Data Centre
6-8 Julius Ave,
North Ryde,
New South Wales, 2113.

SSDA Accessibility Report
15 May 2025
Obvius Access Consultants
For Greenbox Architects

Draft SSDA Access Report- Data Centre, 6-8 Julius Ave, North Ryde, New South Wales, 2113.

Figure 1 showing Man trap portal.

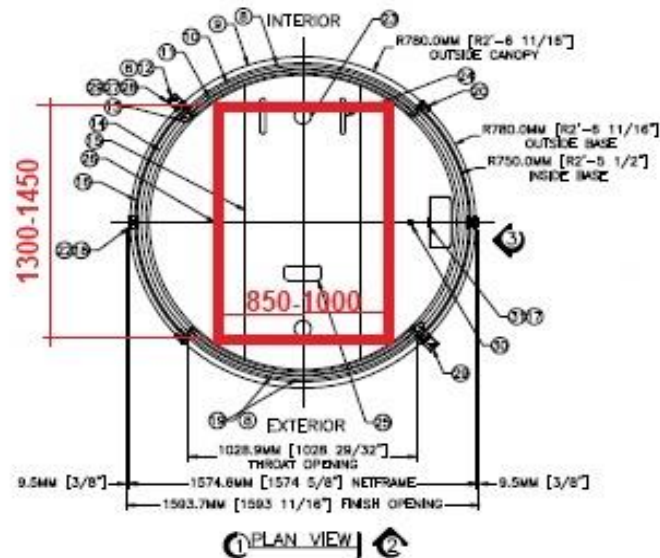
A Man Trap Portal or alternative accessible entry point at the security location between the entrance lobby and the building front of house (FOH) secure areas must meet the intent of the Disability Discrimination Act 1992.

In accordance with AS1428.1:2009 Clause 6.1 revolving doors or turnstiles are not a continuous accessible path of travel.

Where Man Trap Portals are provided at least one small room/vestibule designed to trap those who would enter a secure area of the facility should be accessible for a person with a disability. Accordingly, the Man Trap Portal should also allow for an individual to access and exit in the instance of an emergency to the non-secure area, or to use the designated ground floor unisex accessible toilet when provided in the entrance lobby area.

A Man Trap Portal accessible entry point where provided must comply in accordance with AS1428.1:2009 and must be provided with sufficient size of at least a clear 850mm, (1000mm preferred clear width through the entry) and 1300mm length (1450mm preferred), which is the footprint of the 90 percentile of wheelchair users in accordance with AS 1428.1:2009. Refer to Figure 1 below.

A Threshold Ramp must be provided at the Man trap Portal, if a threshold exists at the Man trap Portal that exceeds 3mm in height or 5mm with a bevelled edge. Accordingly, the threshold Ramp to comply in accordance AS1428.1:2009 must not exceed a height of 35mm or exceed a length of 280mm or exceed a gradient of 1:8 and be located within 20mm of the door to which it serves.

The Data Centre project at 6-8 Julius Ave, North Ryde is provided with an alternative Man Trap accessible entry point to the Man Trap Portal.

Door circulation in accordance with AS1428.1:2009 Clause 13.3 figure 31 is provided to the Man Trap. It is also be provided with a clear 2070 x 1540 mm turning space at the entry point door to enable a wheelchair user to complete a 180° turn if required.
